ATmega48PA/88PA/168PA Automotive

Silicon Errata and Data Sheet Clarification

3.3.1 PN

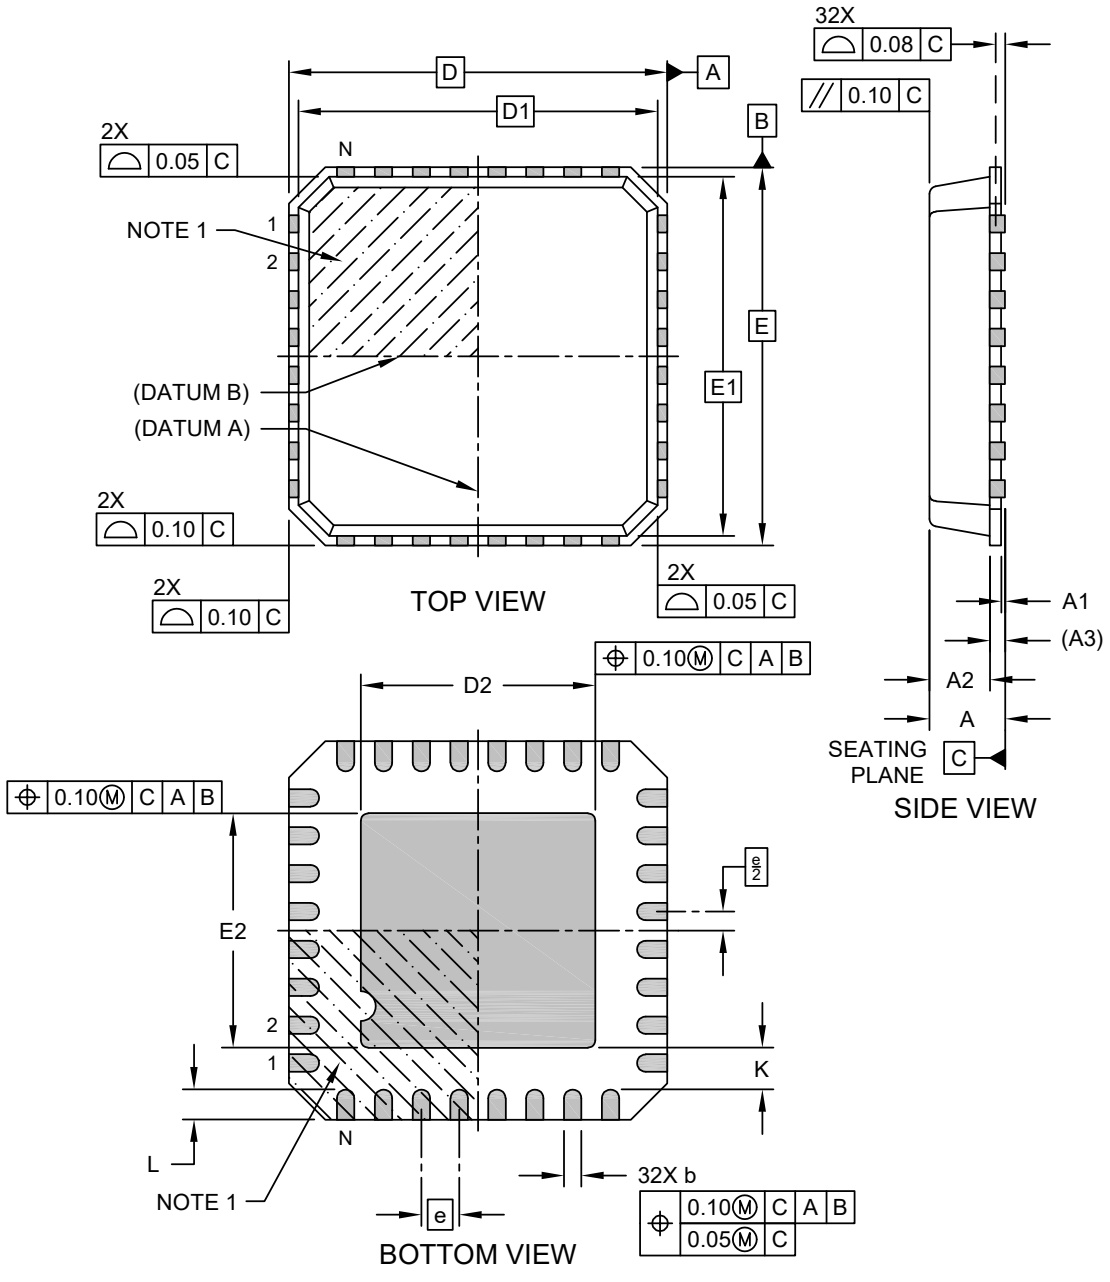
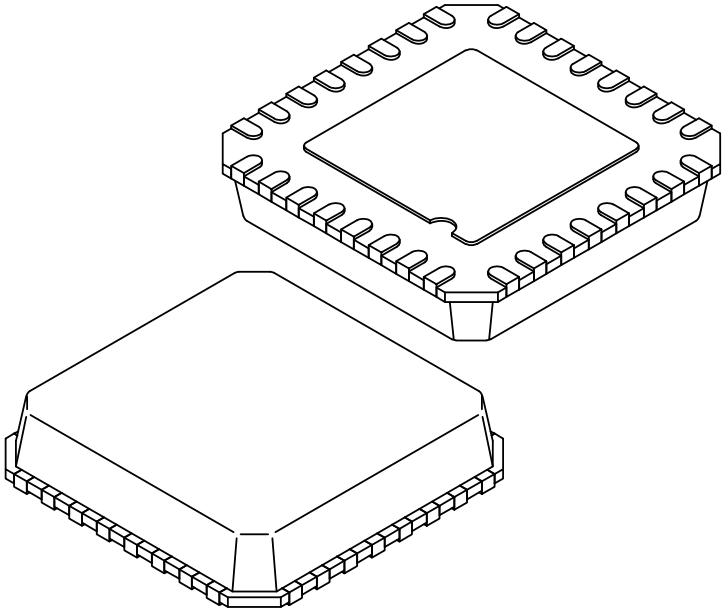
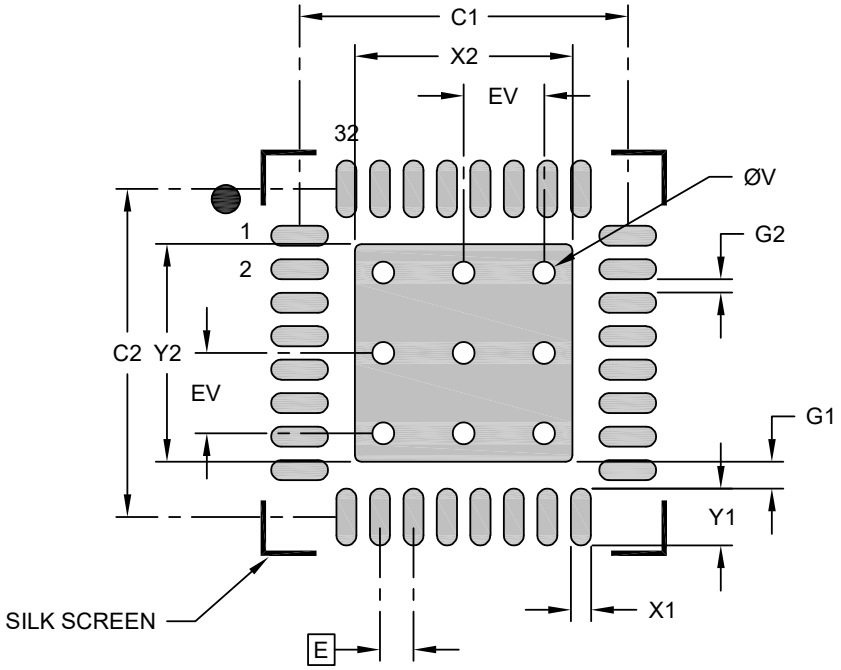
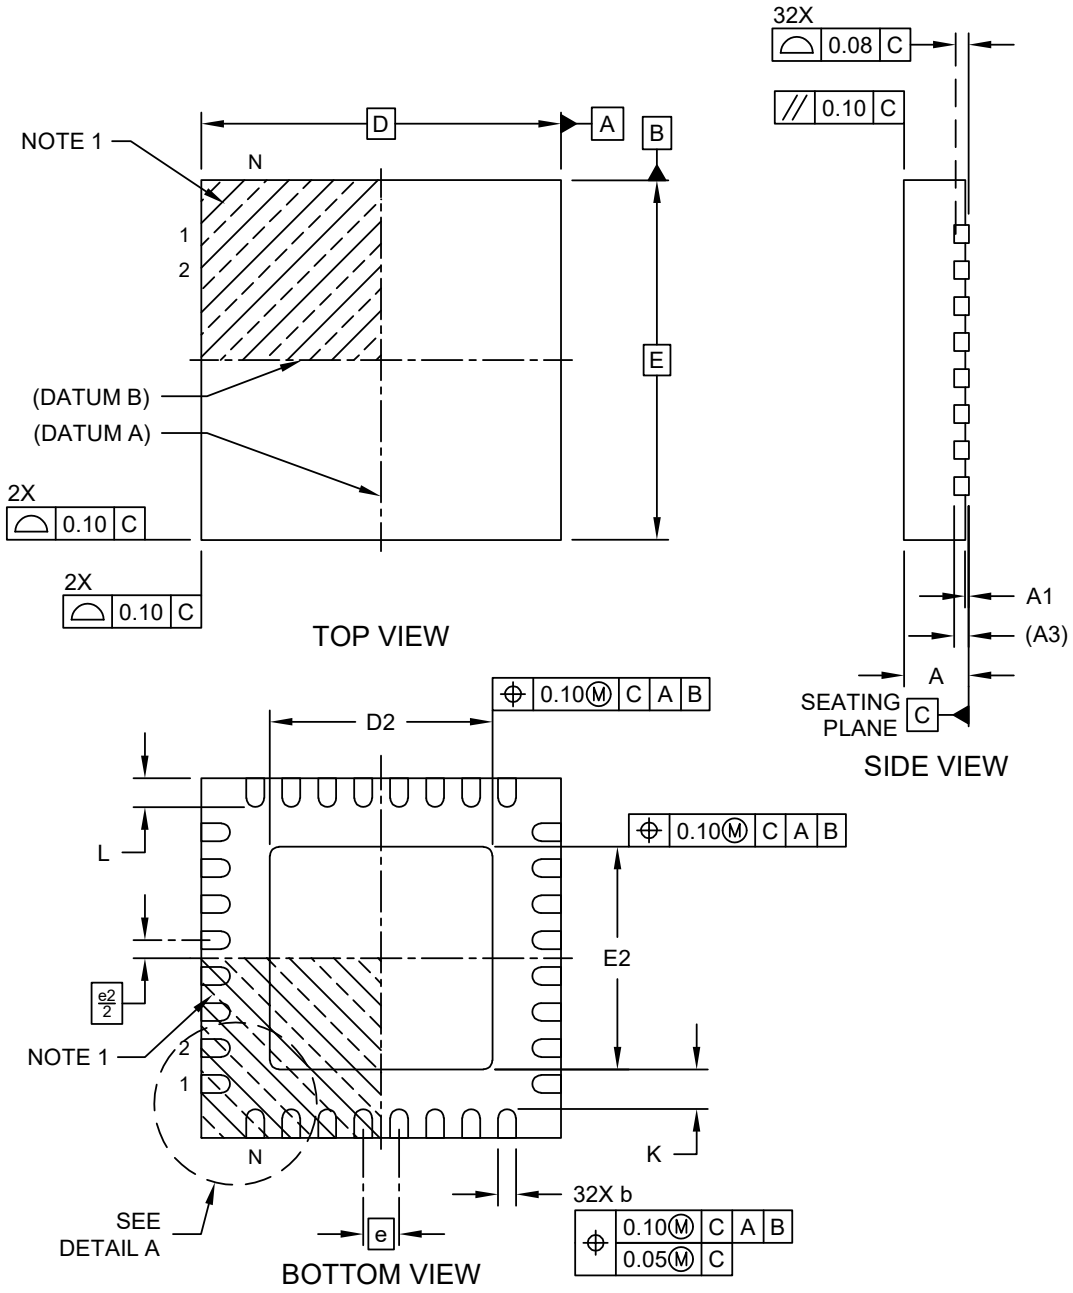
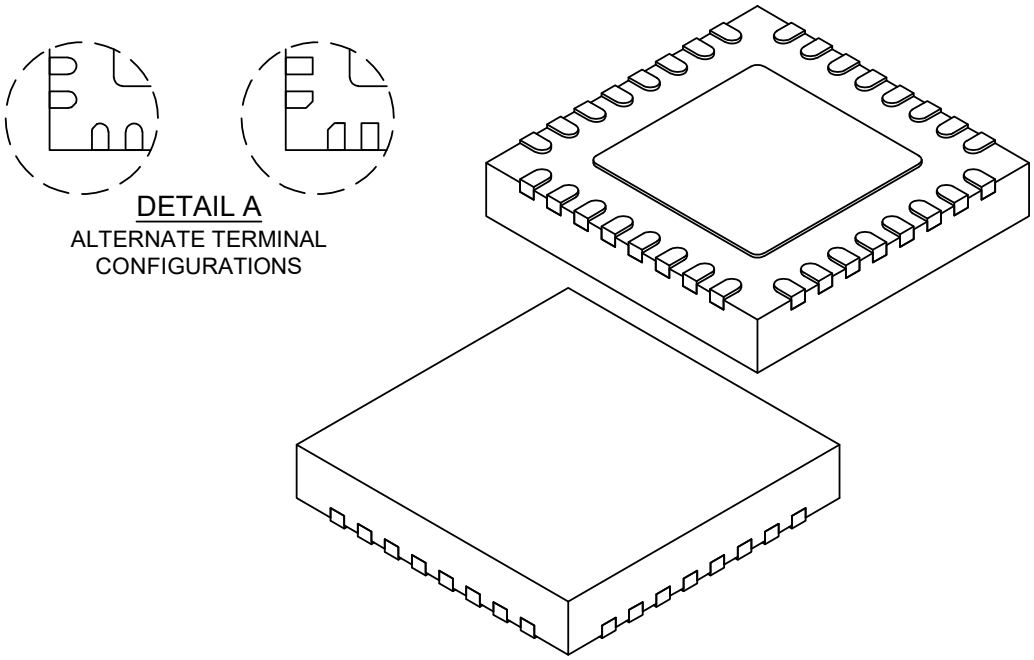
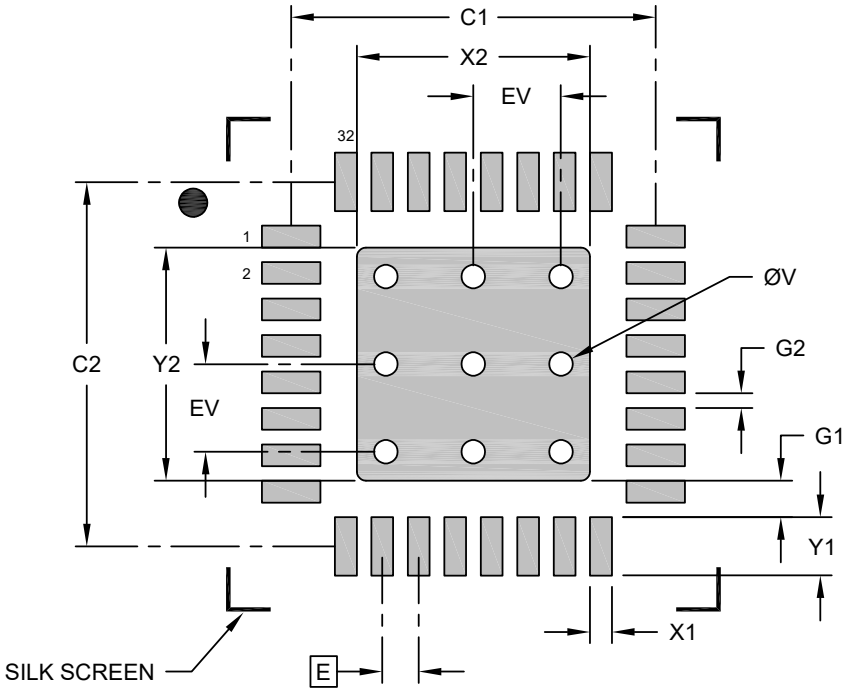
A clarification has been made to tables titled ‘Package Type’ for all devices documented in the data sheet:

- A note to the PN row was added informing that the package type can be delivered in two different styles

1. This package type can be delivered with two different styles in reference numbers ‘C04-21400’ (punched) and ‘C04-21395’ (sawn), as shown in section 3.3.1. PN. For PCB layouts, it is recommended to consider both *recommended land patterns*.

Figure 3-1. Analog-to-Digital Converter Block Schematic Operation

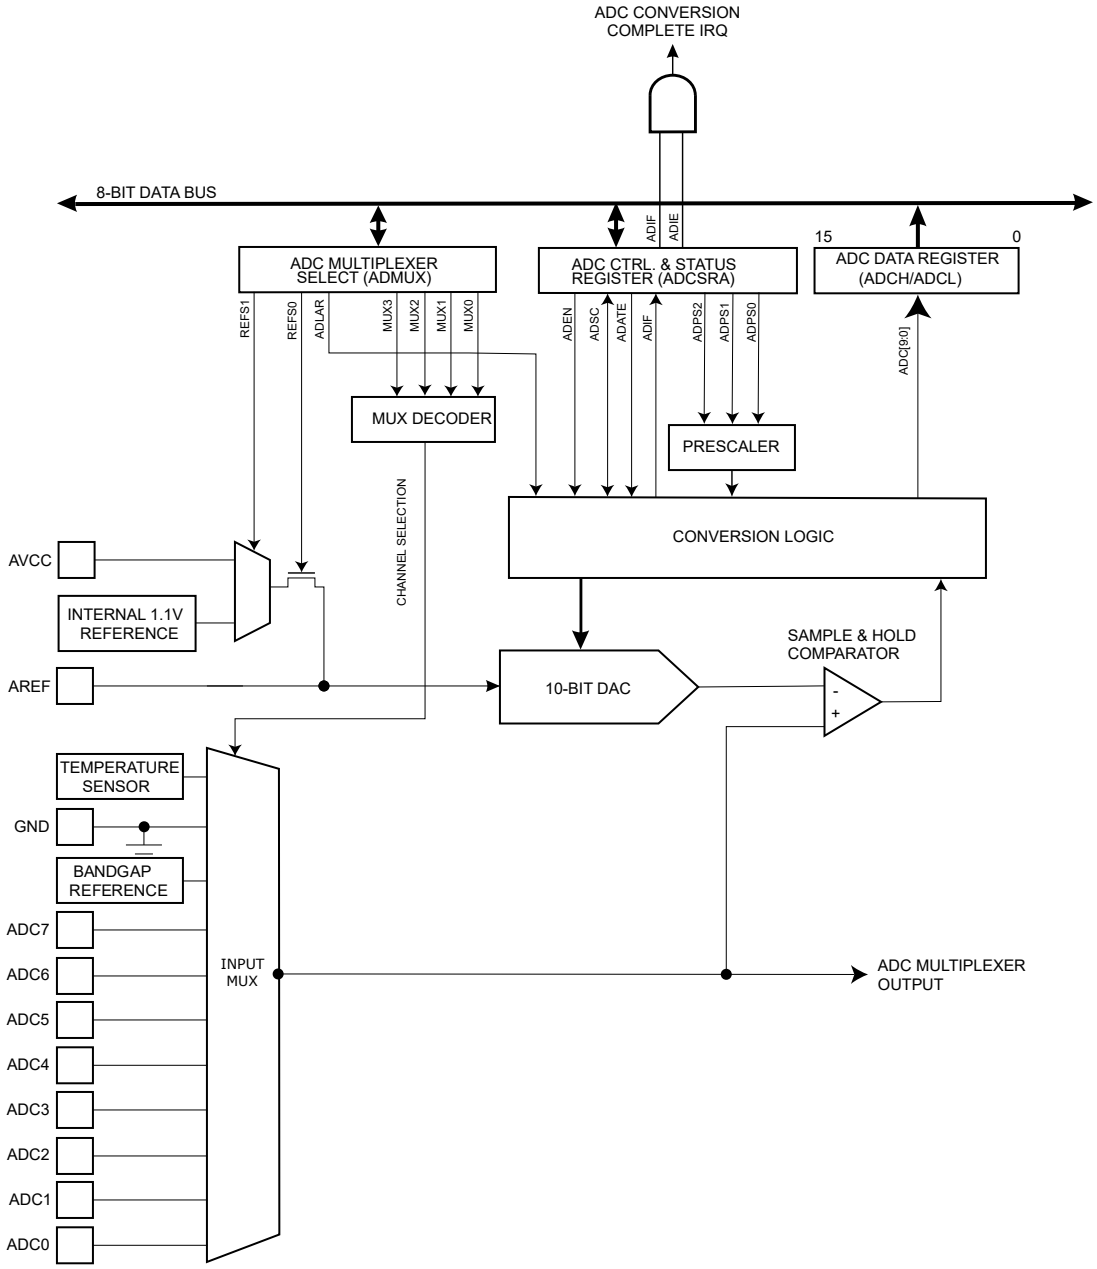
A clarification for the Analog-to-Digital Converter (ADC) block diagram has been made.

In the ADC block diagram ADFR is changed to **ADATE**, and **ADSC is now bidirectional**.
